**PLEASANT PRAIRIE PLAN COMMISSION MEETING
VILLAGE HALL AUDITORIUM
9915 39th AVENUE
PLEASANT PRAIRIE, WISCONSIN
6:00 P.M.
AUGUST 25, 2014**

- A. Consider the request of Daniel Pratt, of Arco Murray, agent for the owner of Good Foods Group LLC, for approval of **Site and Operational Plan** for the construction of a 39,166 square foot addition to the facility located at 10100 88th Avenue in LakeView Corporate Park.

TO: Jean Werbie-Harris, Community Development Director
FROM: Doug McElmury, Chief Fire & Rescue Department
CC: Deputy Chief, Craig Roepke
Lt. Thomas Clark, Fire & Rescue Department
Peggy Herrick, Assistant Planner, Community Development
SUBJECT: Review of the Good Foods Expansion Plans
DATE: 22 August, 2014

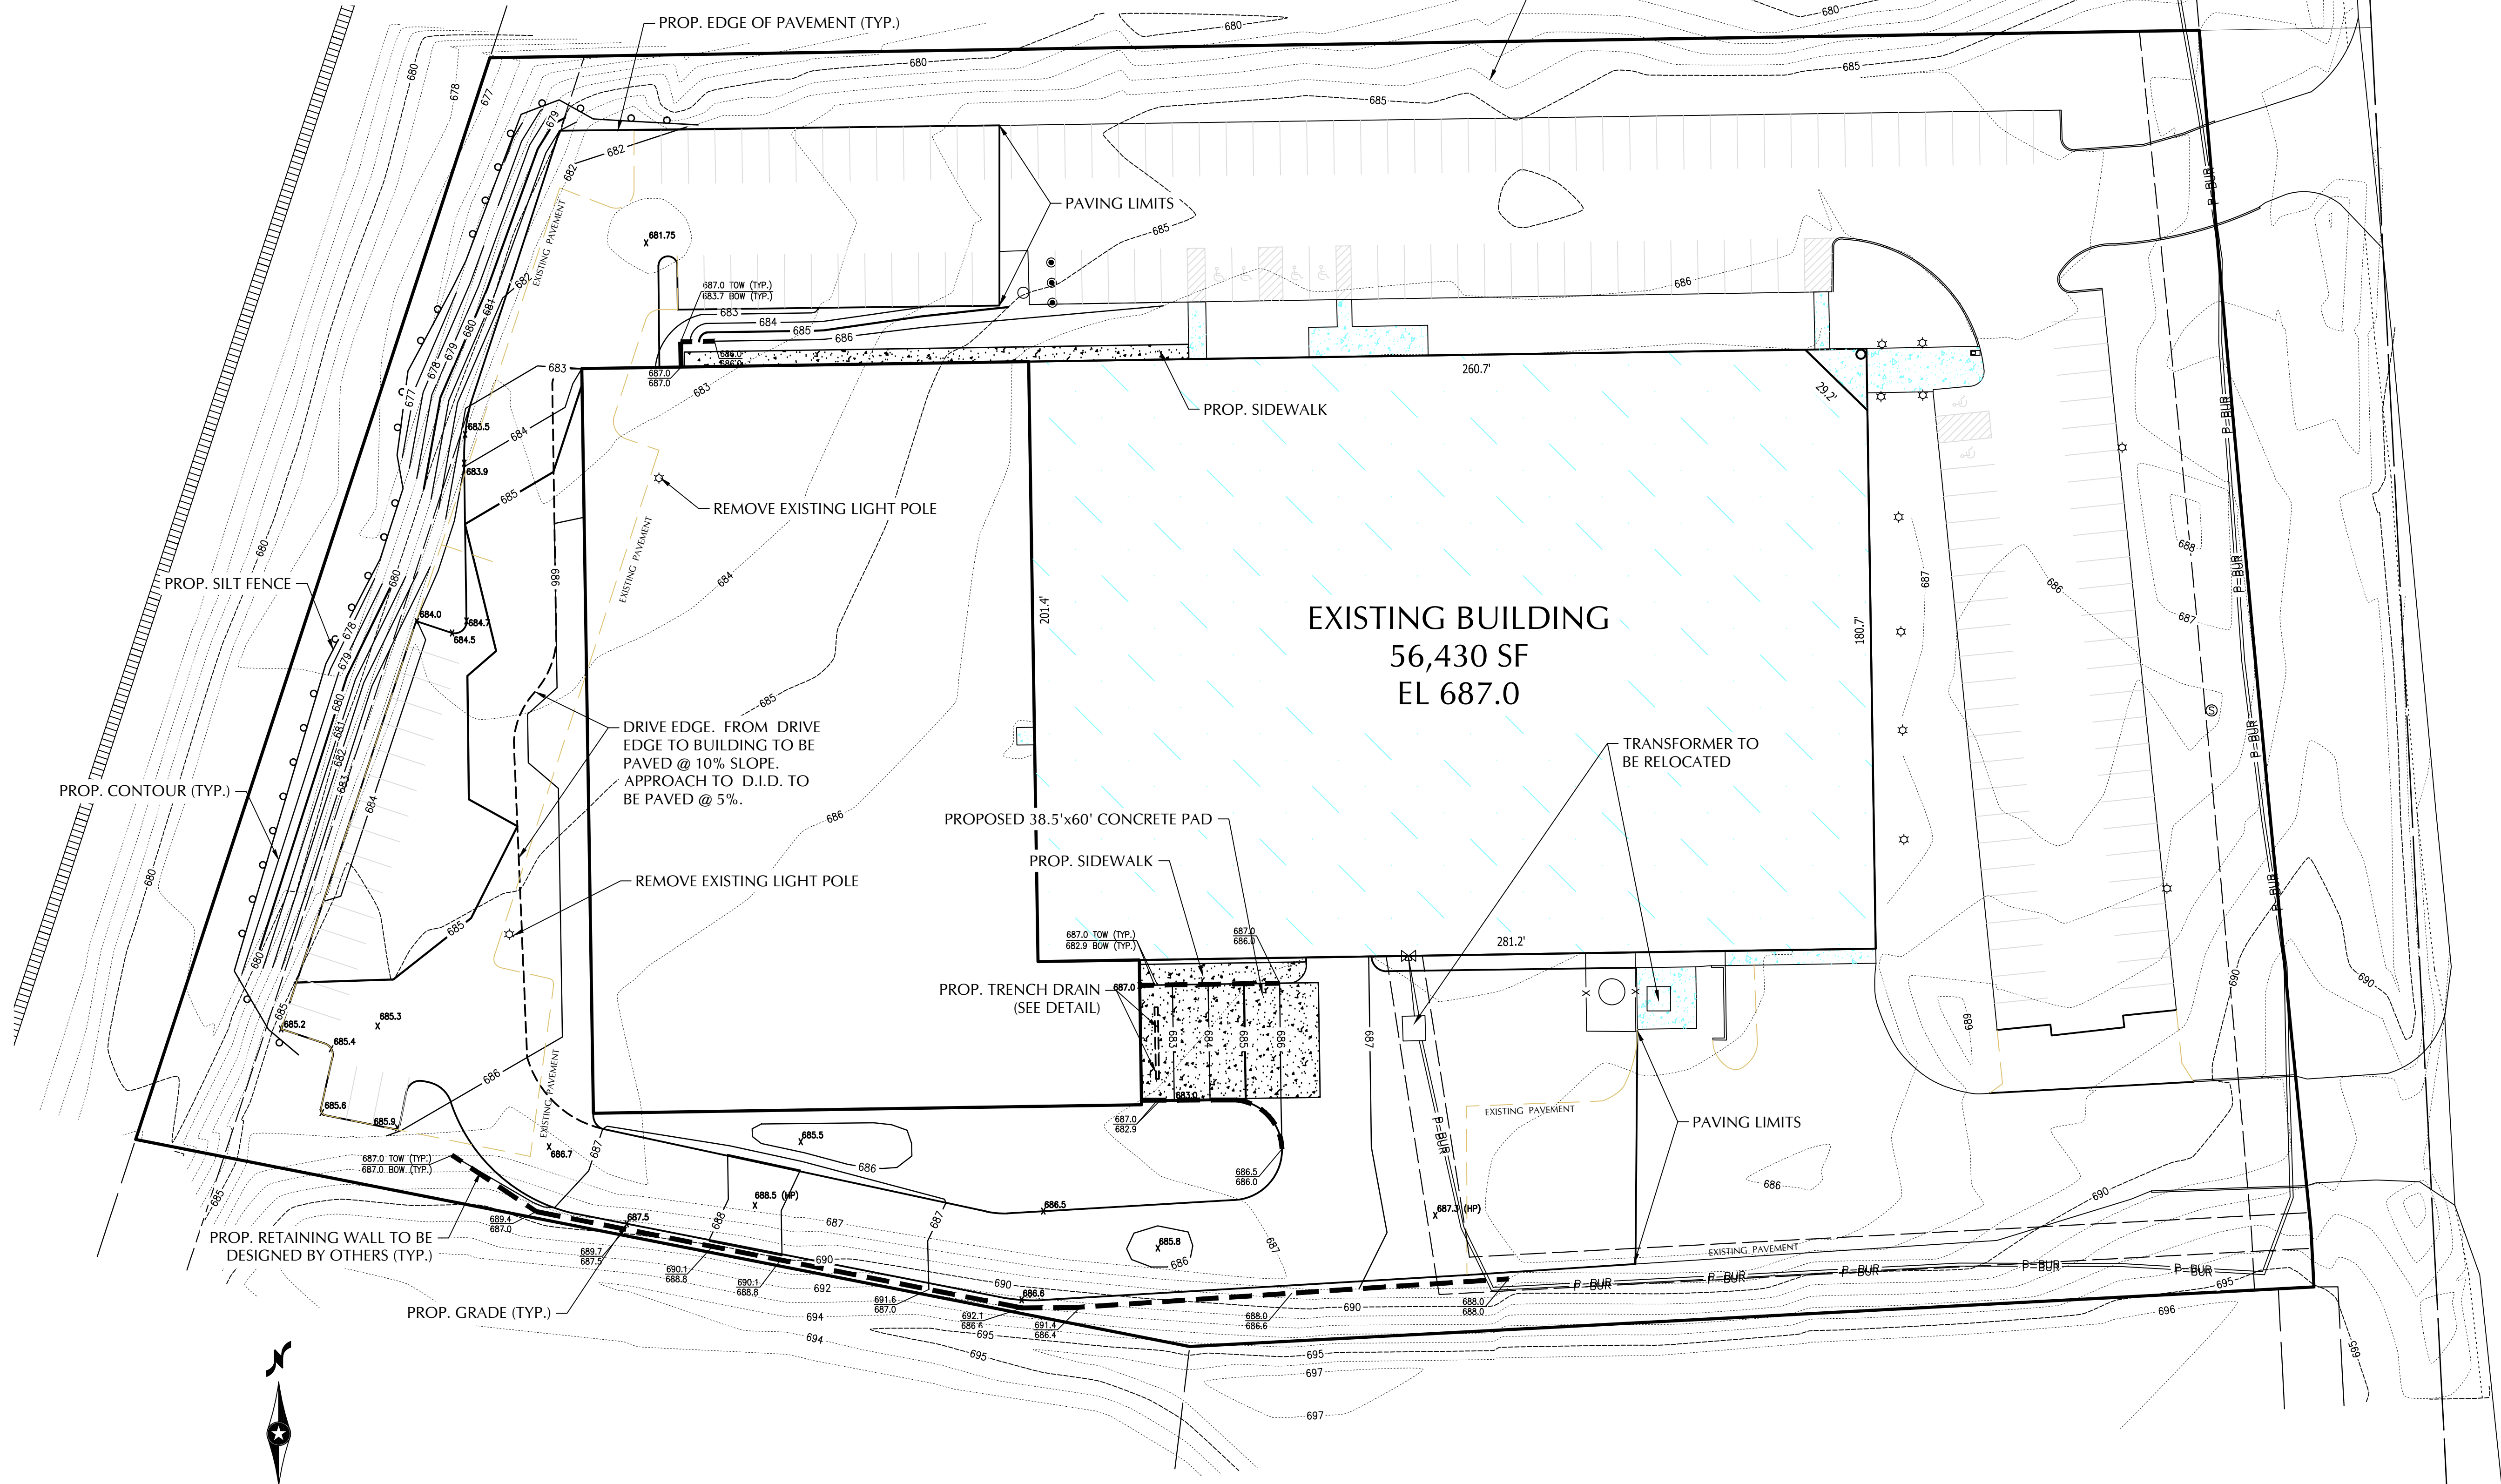
- u. Is the asphalt pavement all heavy duty pavement per the detail?
 - v. Extend the silt on the north side, east past the entire new project limits. Extend the silt fence on the south side parallel to the 685 contour to the property line.

- w. The plan shall show temporary inlet protection locations.
 - x. Reference the existing drainage way and project limit on the grading plan and note "no work or fill to be placed in existing drainage way".

- The parking lot for cars on the east side of the building shall be connected to the south fire lane
- All exit/entry doors shall have a hard surface leading to another hard surface such as a sidewalk, fire lane or parking lot. This is not shown on Sheet C-3

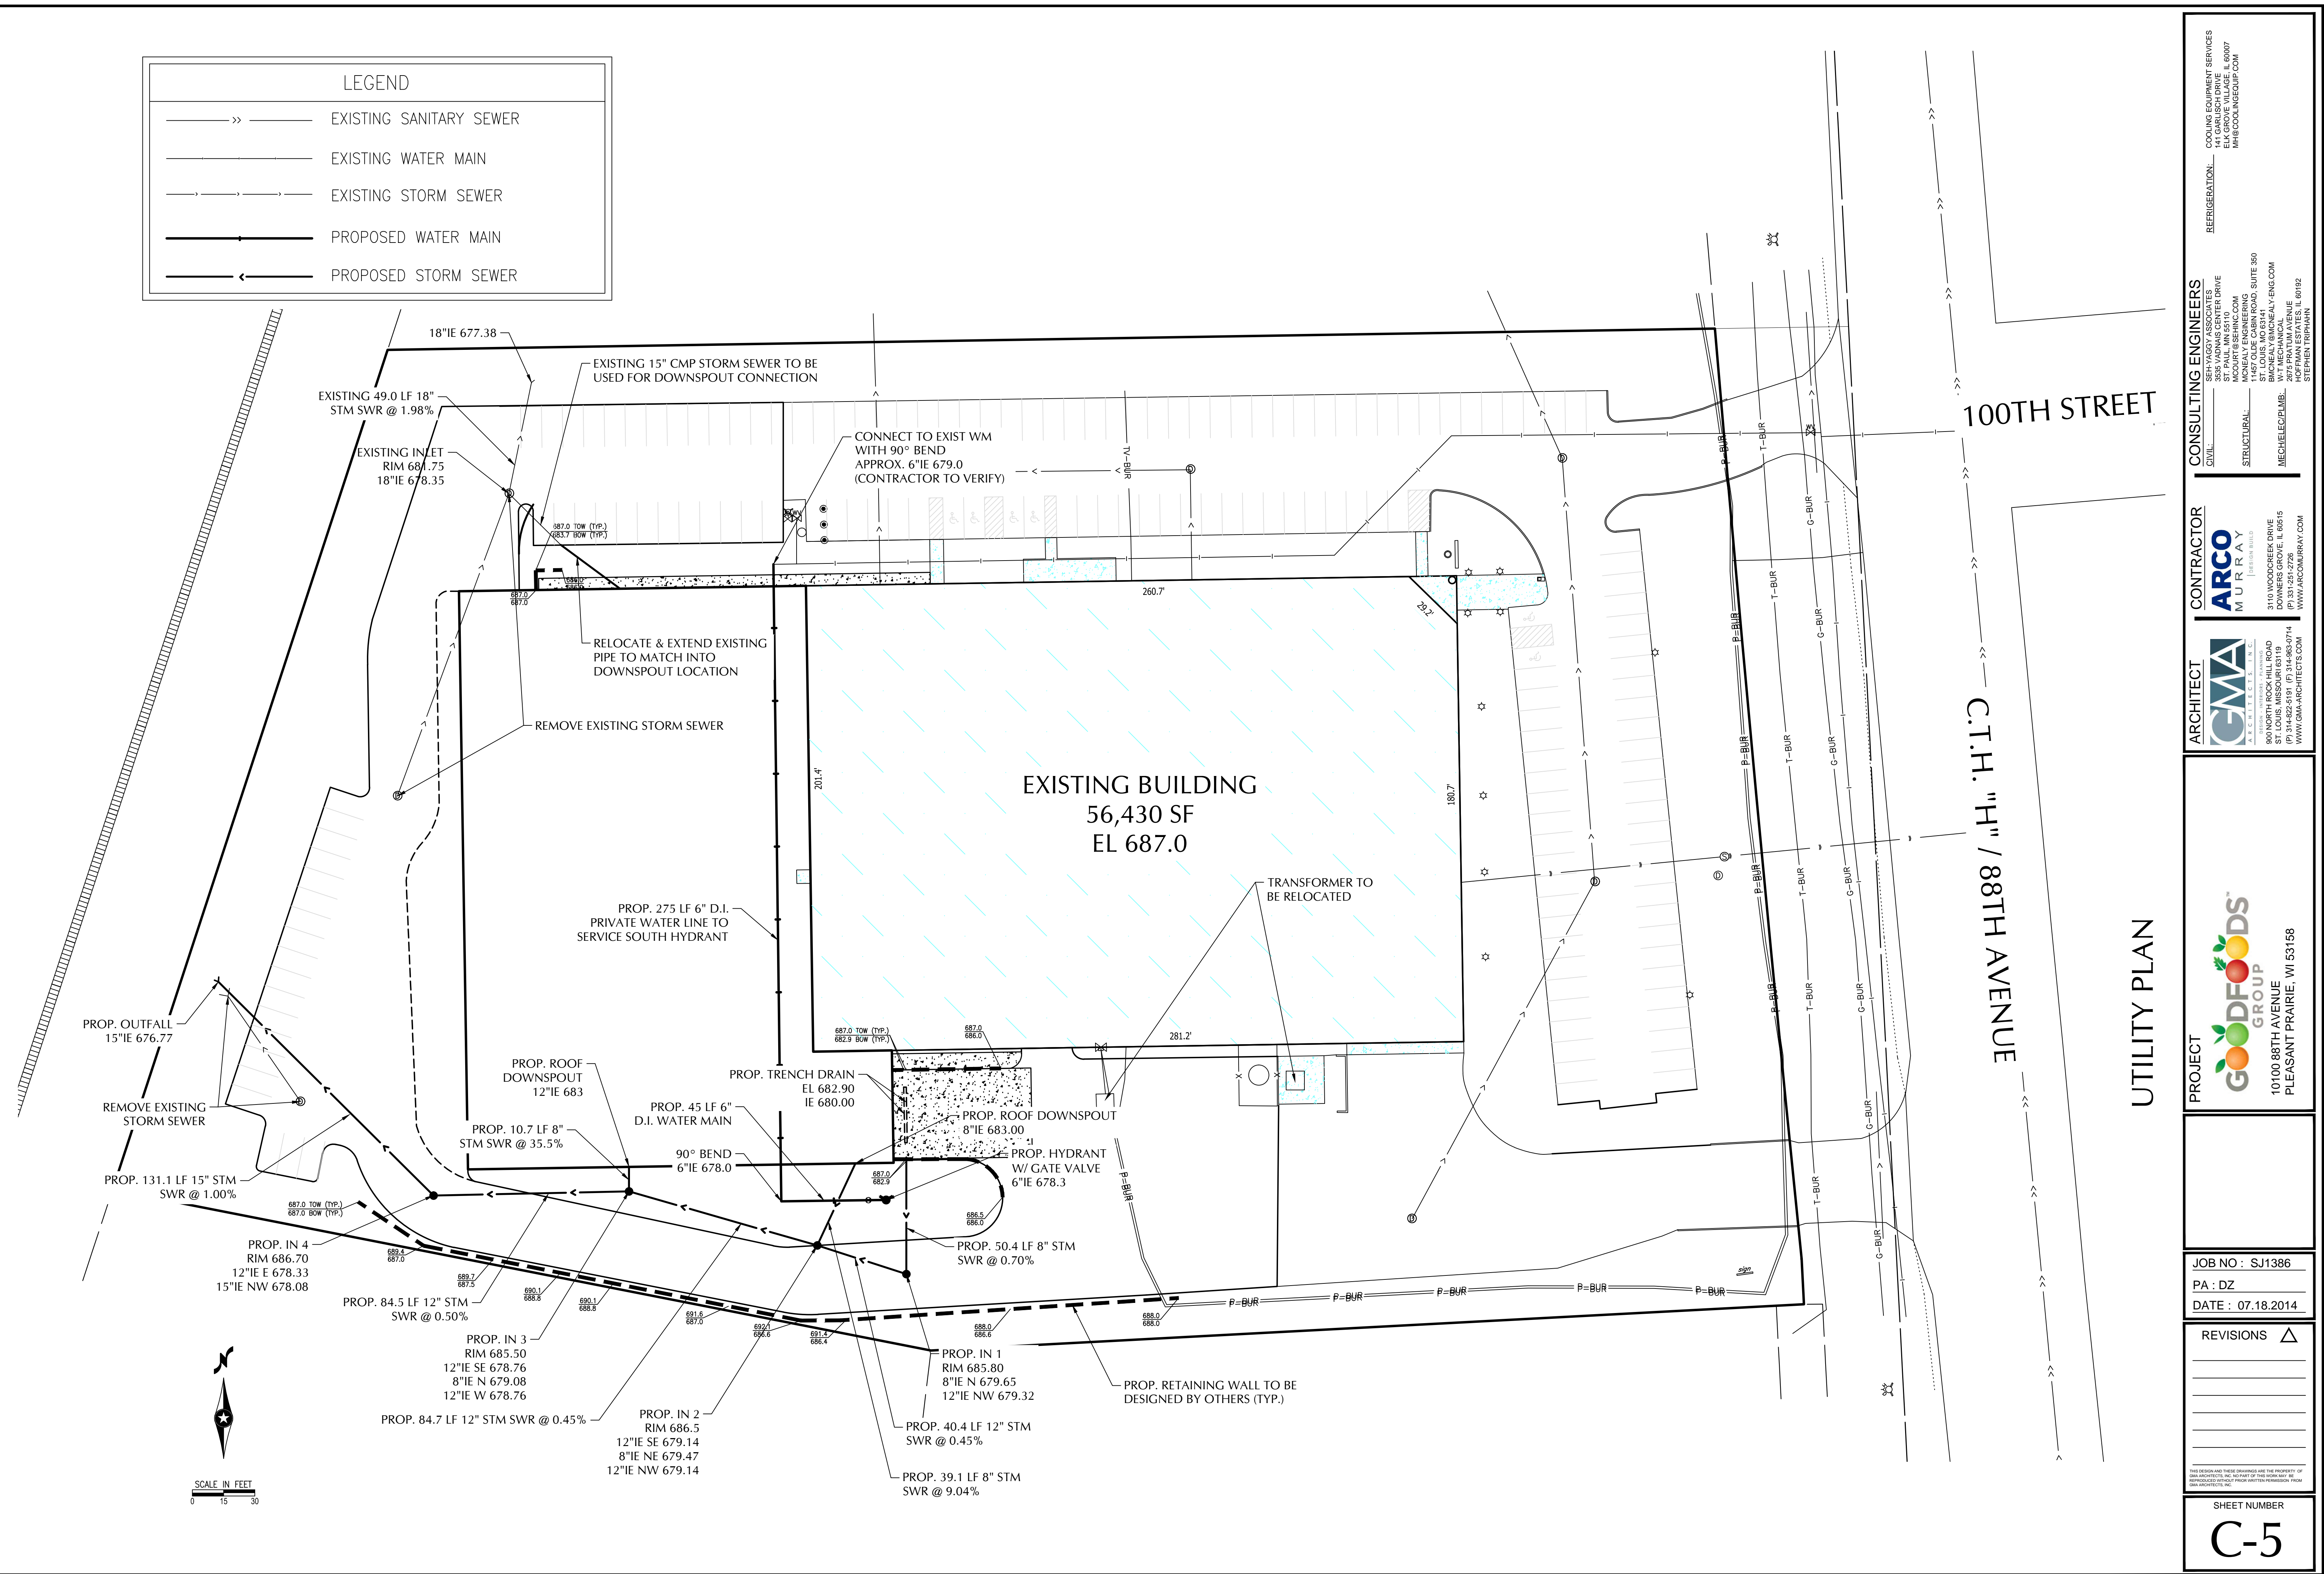
- Water mains shall not run under the building as shown on Sheet C-5. Consider feeding the new hydrant on the south side of the building directly from the municipal water main on 88th Ave.
